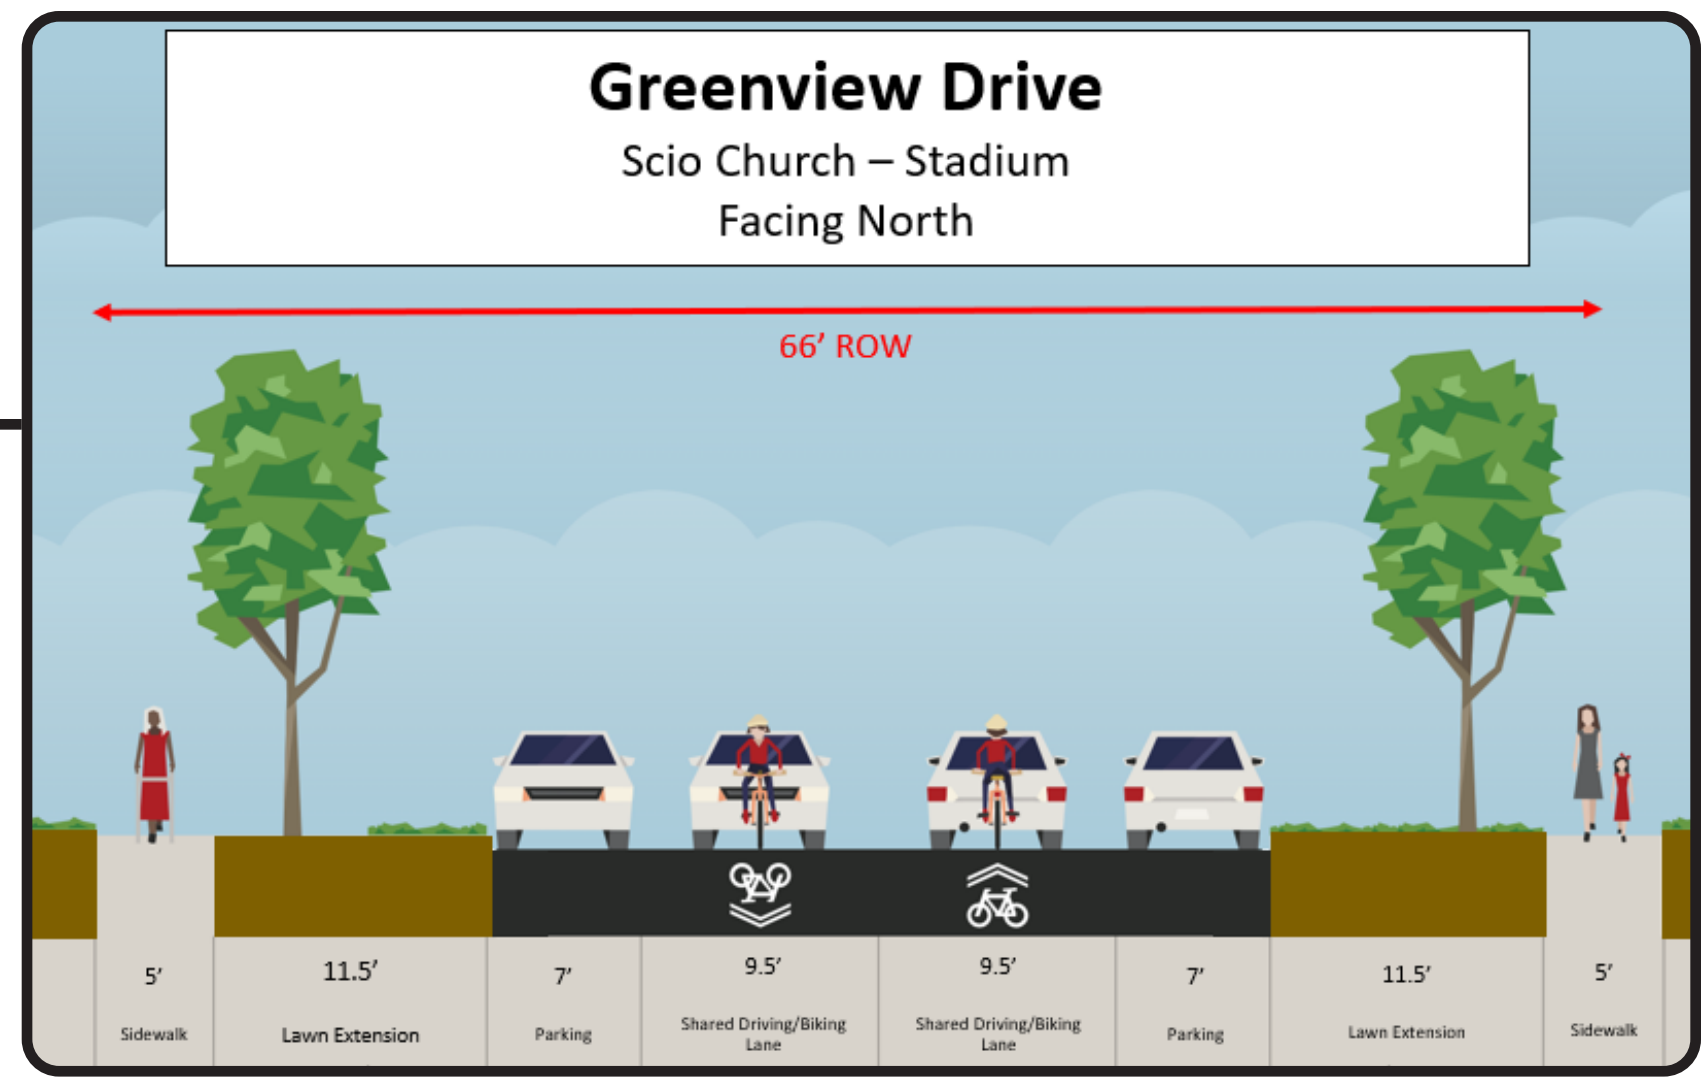
Change Made with Public Input

A mid-block crossing was removed here.

Legal on-street parking is maintained on both sides of the street.

The road was narrowed from 36 feet to 30 feet to match adjacent neighborhood roads.

Change Made with Public Input

The Avondale intersection bump out was shortened to accommodate more on street parking. A crosswalk on the north side was removed here.

Change Made with Public Input

A crosswalk was removed here.

Change Made with Public Input

The area between bump outs was widened from 20 feet to 24 feet to increase bicycle comfort.

The centerline was removed to give Greenview Drive a more residential feel.

Change Made with Public Input

Bump outs were made with a softer angle for easier snowplowing.

It was suggested that a crosswalk be placed on the south side of the Barnard intersection because there is a school bus stop here. This could not be done because a utility pole is located there.

Bump outs were also placed to prevent parking at intersections on busy days like football Saturdays.

Sharrows were added to remind all users that this road is shared between drivers and bicyclists.

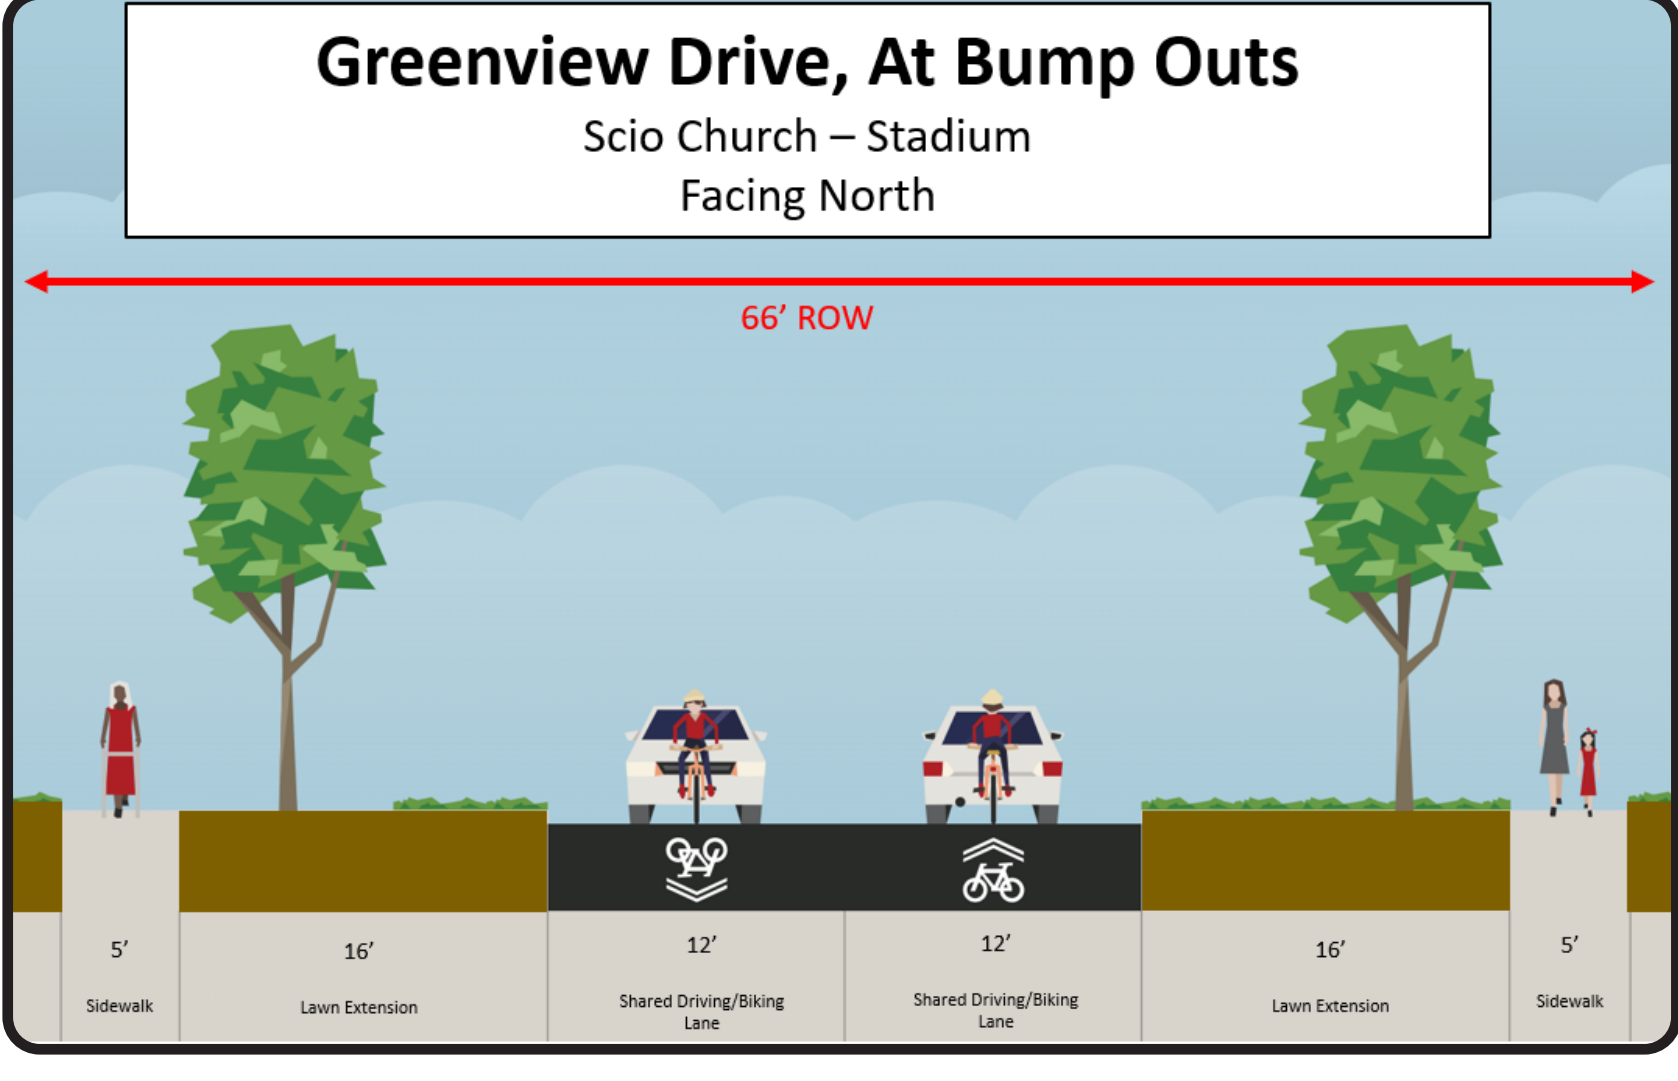
This illustration depicts the road layout in the areas without bump outs. There is enough room for two travel lanes and two parking lanes by using the 18-inch gutter pan for parking.

This illustration depicts the road layout in the areas with bump outs. There are two 12-foot travel lanes between bump outs.
